From: [Cornelis Duba](#)
To: [Thomas Piovesan](#)
Cc: [Andrew Watson](#)
Subject: NSW Planning & Environment SSD-8800 RtS for EIS Parramatta Leagues Club Hotel - Response from Endeavour Energy
Date: Tuesday, 18 January 2022 9:59:59 AM
Attachments: [image007.png](#)
[image006.png](#)

I refer to the Department's below email of 17 January 2022 regarding the Response to Submissions (RtS) for the Environmental Impact Statement (EIS) for State Significant Development SSD-8800 Parramatta Leagues Club Hotel at 1 Eels Place, Parramatta [Lot 369 DP 752058, Lot 7054 DP 1074335 & Residual Crown Plan 80-3000 (Sydney)] for 'Construction of a 17 storey hotel comprising 209 hotel rooms, one basement level for services, ancillary uses including a pool, gym, cafe, bars and function room, vehicular access from O Connell Street, public domain works and tree removal'. Submissions need to be made to the Department by 7 February 2022.

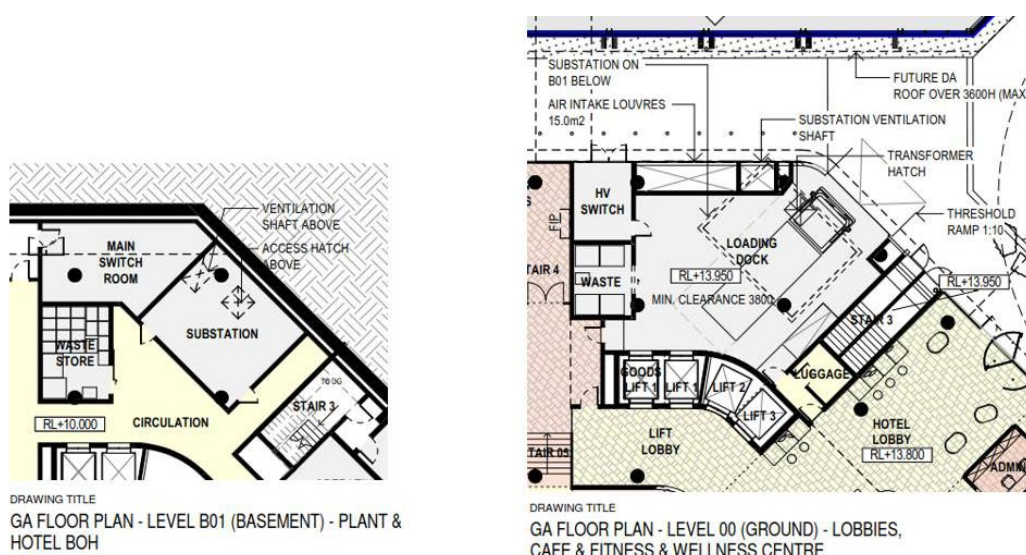
The following extracts of the updated Architectural Drawings show the proposed indoor substation has been relocated but remains in the basement.

The RtS acknowledges Endeavour Energy's submission made to the Department on 21 February 2019 for the EIS but does not appear to provide any further advice / update regarding the provision of electricity supply to the proposed development. Accordingly the recommendations and comments provided in Endeavour Energy's submission for the EIS remain valid.

In regard to the Civil Engineering report which addresses the flood risk over the site, Endeavour Energy requires the

electricity network needed to service an area / development to be fit for purpose and meet the technical specifications, design, construction and commissioning standards based on Endeavour Energy's risk assessment associated with the implementation and use of the network connection / infrastructure for a flood prone site. Risk control has focused typically on avoiding the threat, but where this is not possible, reducing the negative effect or probability of flood damage to assets by implementing good design and maintenance practices.

Distribution substations should not be subject to flood inundation or stormwater runoff. Section 7 'Substation and switching stations' of Endeavour Energy's Mains Construction Instruction MCI 0006 'Underground distribution construction standards manual' provides the following details of the requirements for flooding and drainage in new distribution substation locations.

Substations are to be located such that the risk of flooding or stormwater damage is minimal.

As a minimum the level at the top of the transformer footing, HV and LV switchgear, shall not be lower than the 1:100 year flood level.

In areas where, as determined by the Network Substation Manager, there is a high water table or a heightened risk of flooding, indoor substations will not be permitted.
